Enclosed in this document is a revised application for Power Plant Siting for the third boiler expansion at the Pinellas County Resource Recovery Facility. It is hoped that the contents contained herein address those comments posed by the Department in a letter dated August 9, 1983.

INDEX TO DEPARTMENT COMMENTS

RE: Pinellas County Resource Recovery
Project, Phase II, PA 83-18
DOAH Case No. 83-2355

APPLICATION FOR POWER PLANT SITING

FIGURE 2.1.b

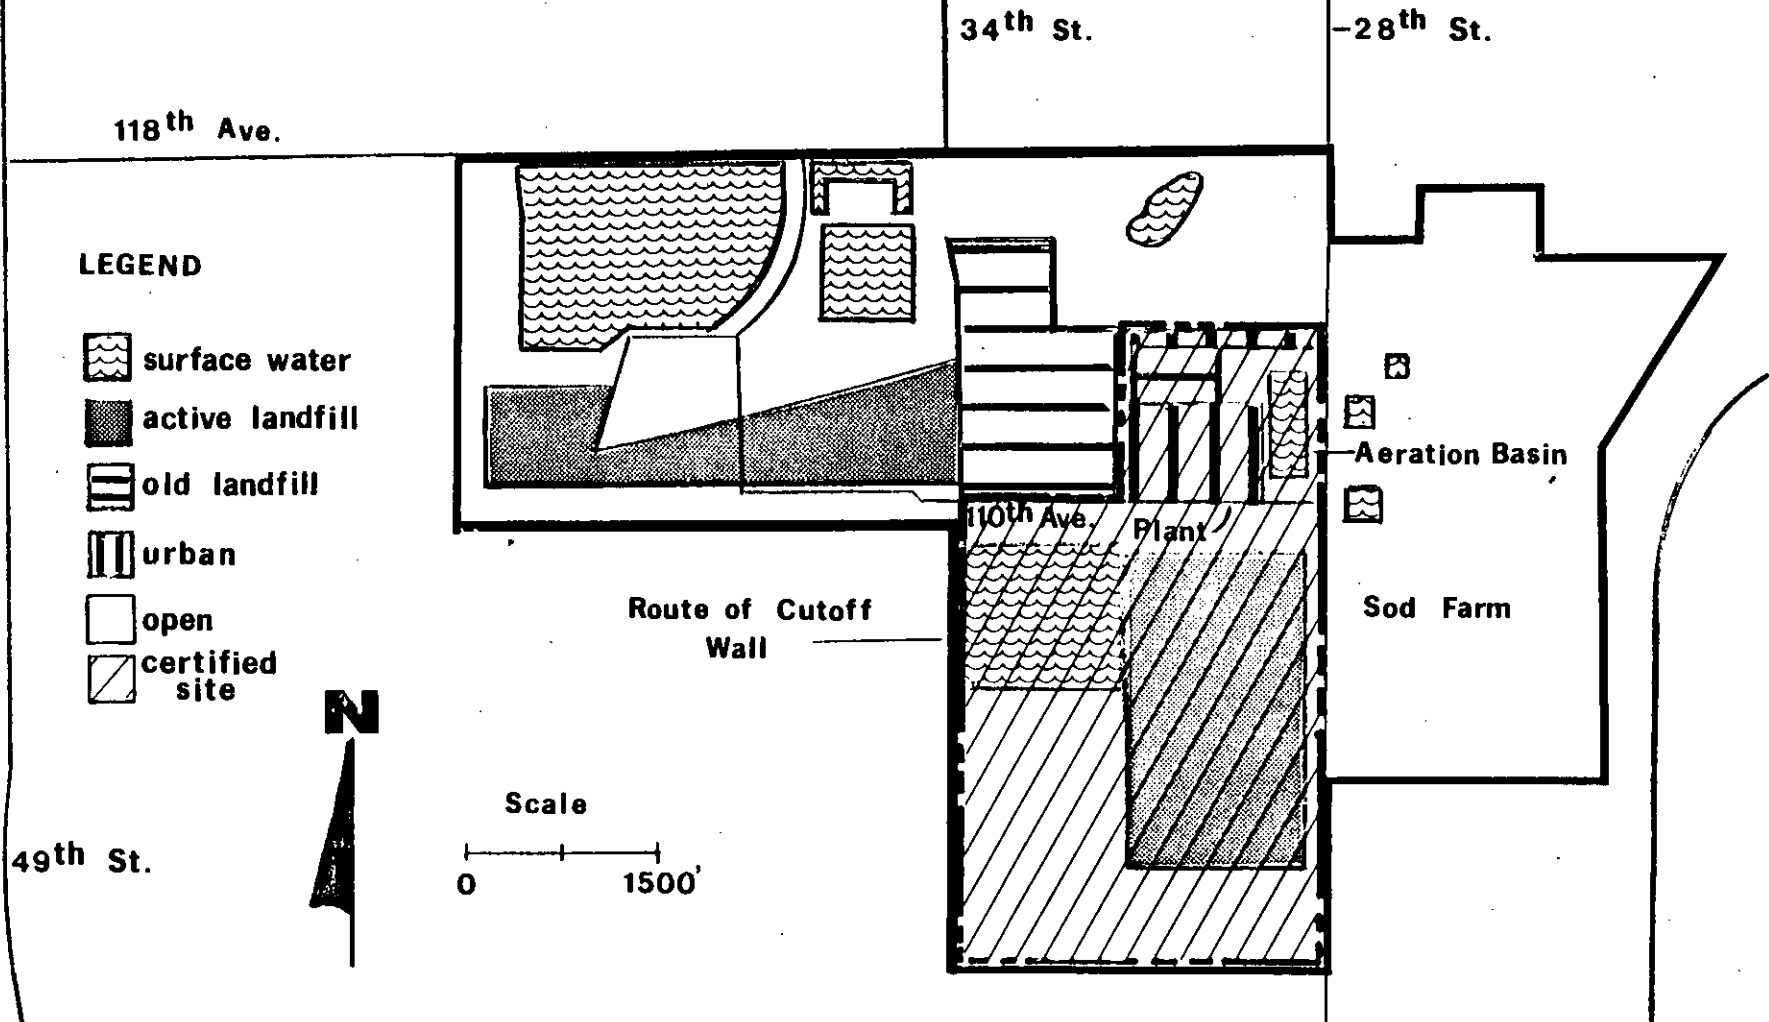
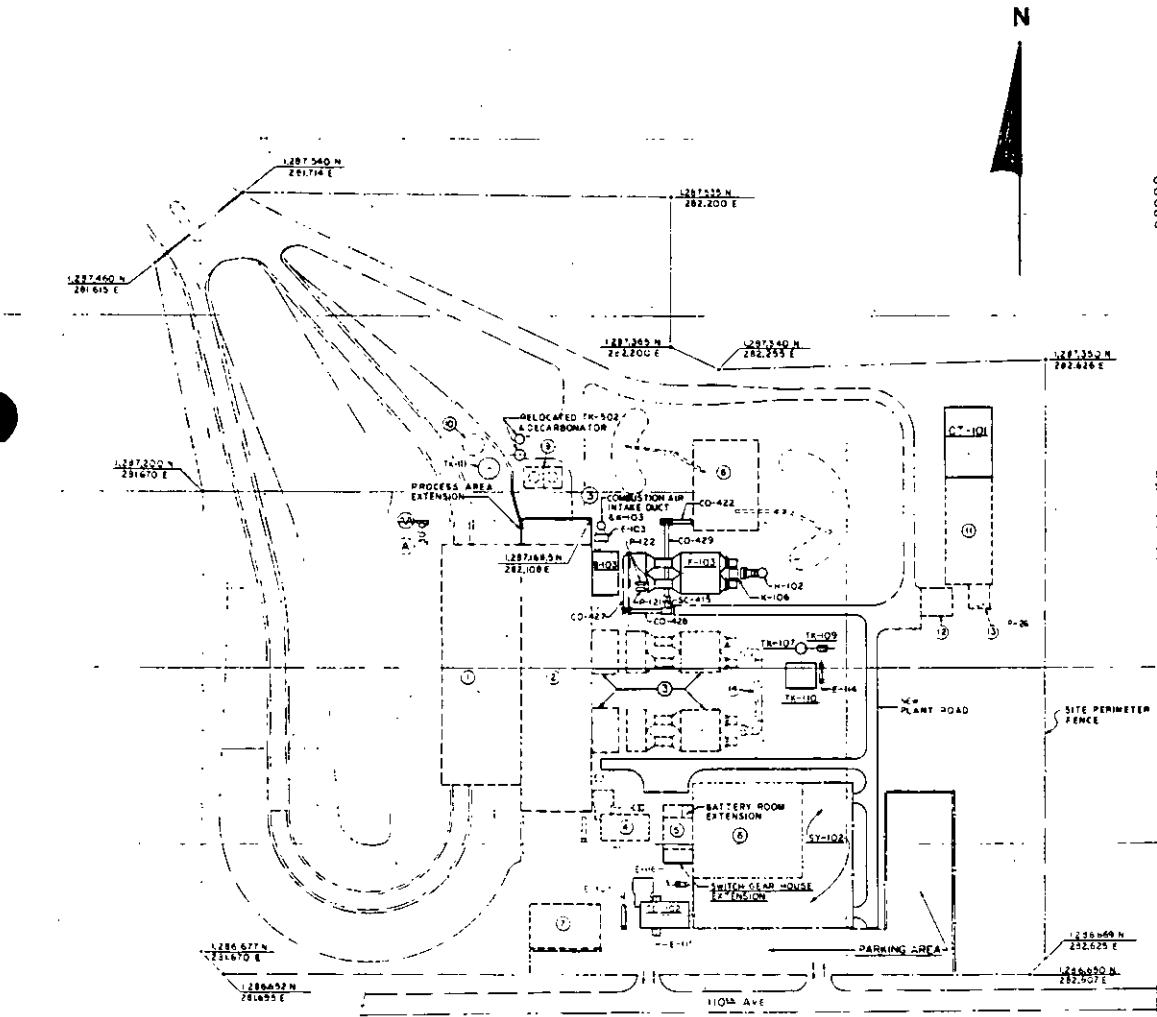
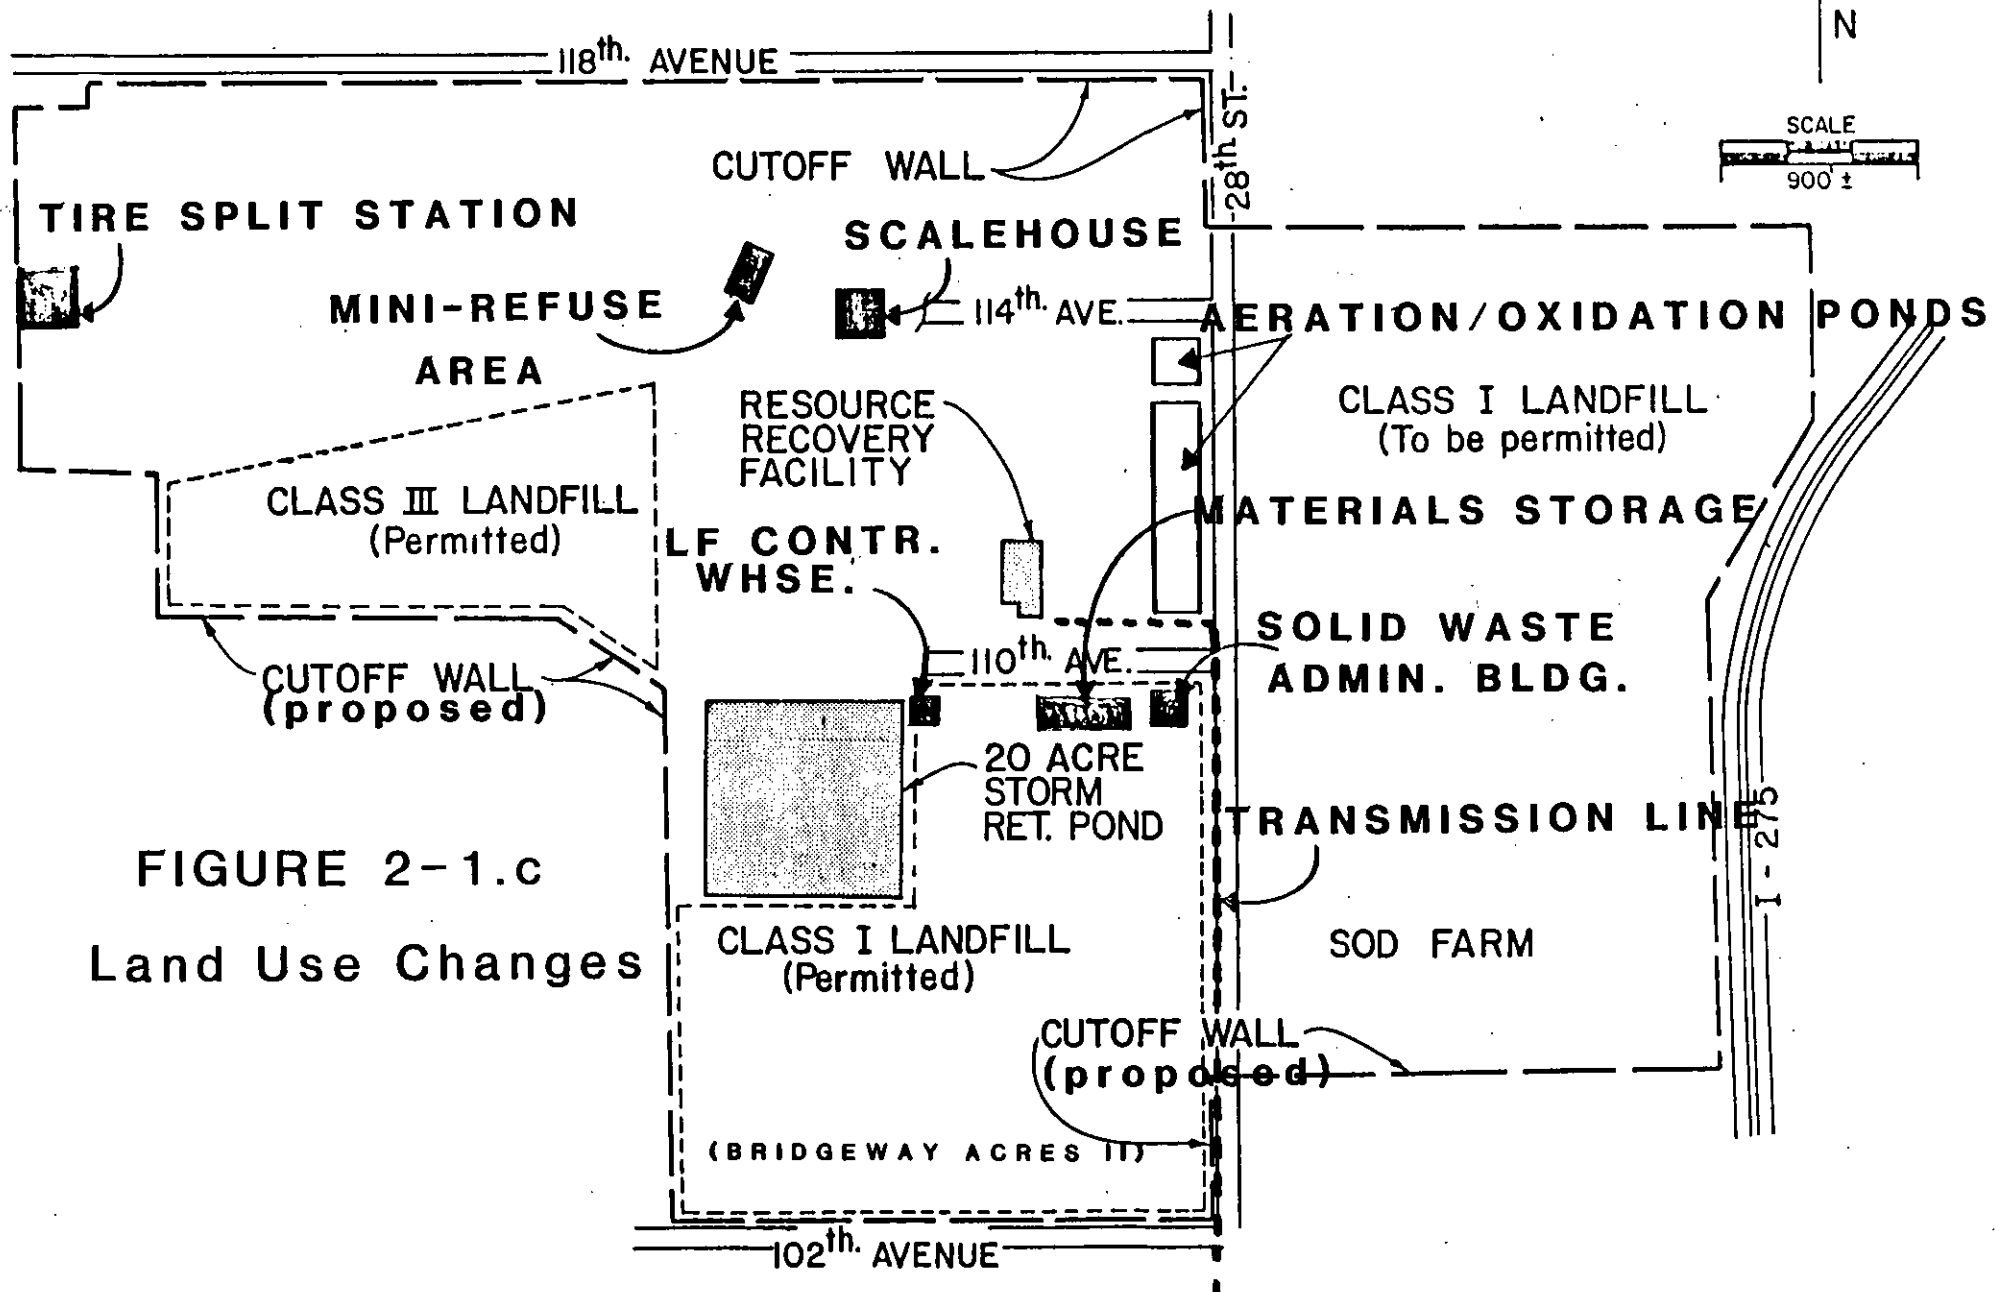
- (3) Chapter 2 - Figure 2.1 is close to illegible and the distinction between what facilities are planned vs. certified but not yet constructed vs. constructed is not apparent. Provide a better Figure. Regarding the site layout depicted on the same figure, what will happen to the materials handling area once construction on the third boiler is commenced?

- Comment 2: A Petition of Need will be filed with the Public Service Commission by September 30, 1983.
- Comment 3: Figure 2.1 was expanded into three separate exhibits. Figure 2-1.a identifies general land use in the vicinity of the Resource Recovery Facility (RRF), Figure 2-1.b identifies the existing and proposed plant layout, and Figure 2-1.c features changes at the RRF since submittal of the original application - See Section 2.1.1. No changes to the materials handling area will be required (page 6).

SUMMARY WATER FLOW DIAGRAM
(BASED ON USING LARGO WATER)

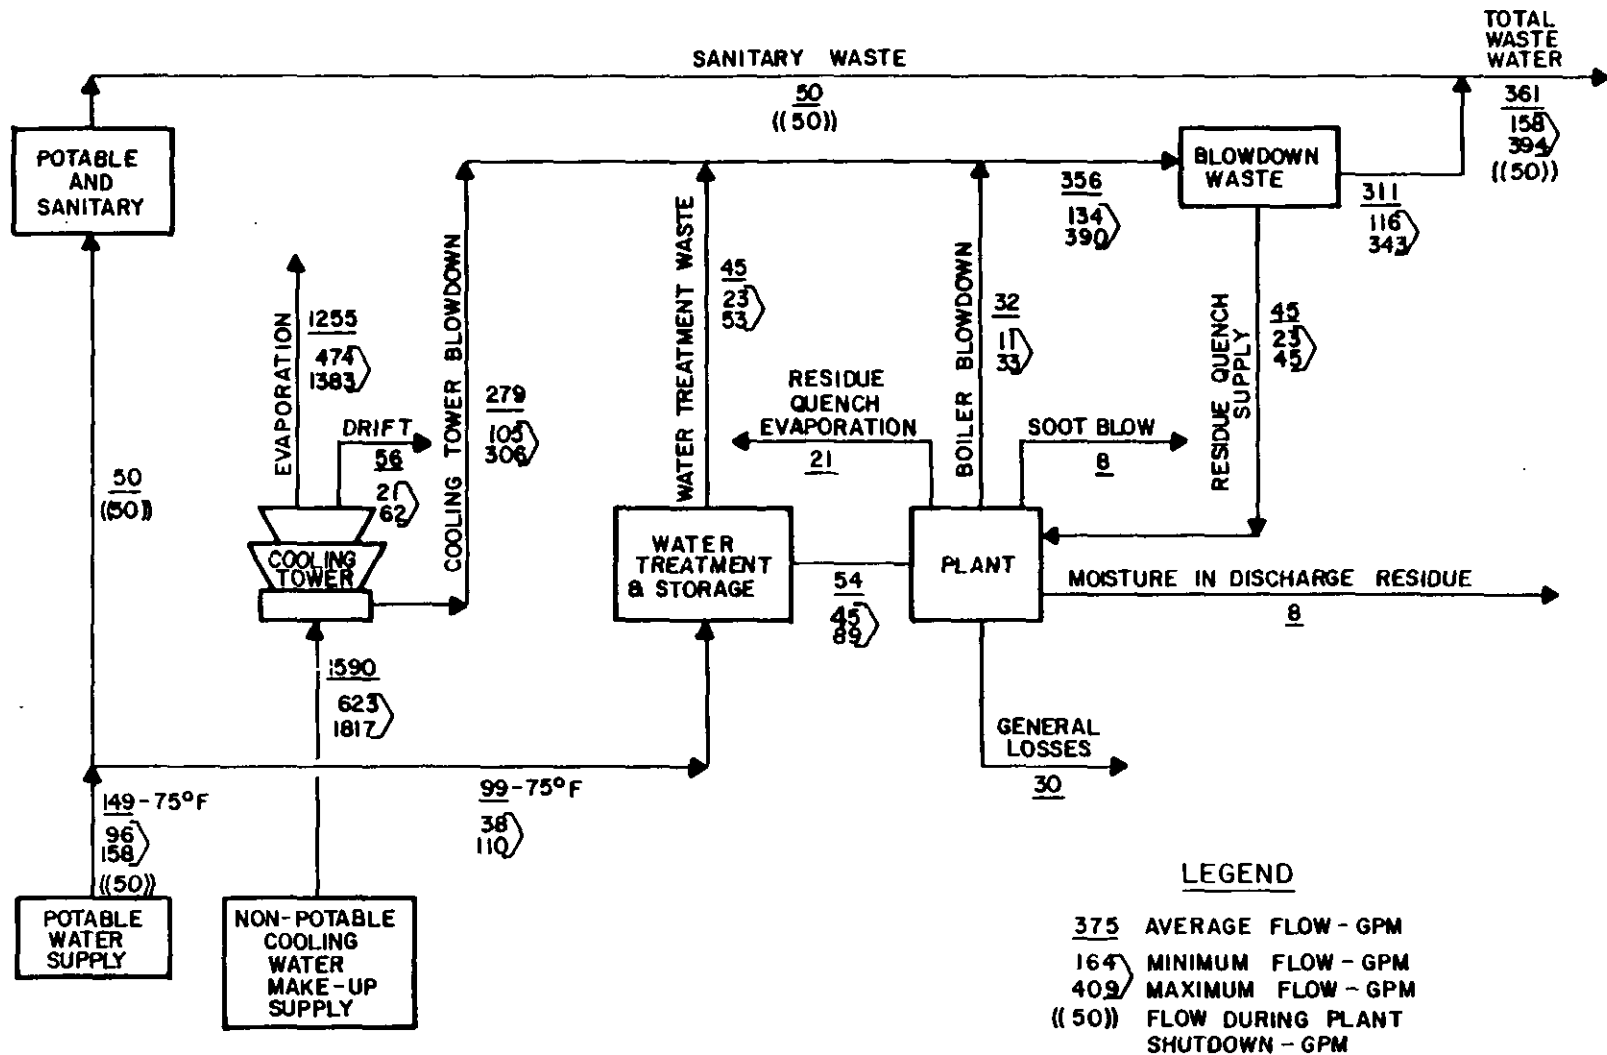
(6) Chapter 3 - Regarding Figure 3.1, the flow volume for the 1983 waste stream appears less than for 1978. It is assumed that the 1983 figures are revised and reflect more accurately the anticipated conditions, but this needs to be clarified. Is there documentation from Pinellas County that the effluent is acceptable? A tabulation of the characteristics of the effluent is needed.

- Comment 5: Details of the proposed bentonite-soil slurry wall are presented in Appendix VIII.
- Comment 6: The reason for the reduced waste stream flow is discussed in Section 3.3, page 21. A letter stating the acceptability of the effluent is presented in Appendix VII.

Figure 3-1 presents the revised design water use rates for normal and peak load operation of the facility with the addition of the third unit. The total water to waste is noticeably reduced from that stated in the original application; this is true even with the installation of a third boiler. This situation is due to the use of a better quality Largo supply with a resultant increase in cooling tower recycles.
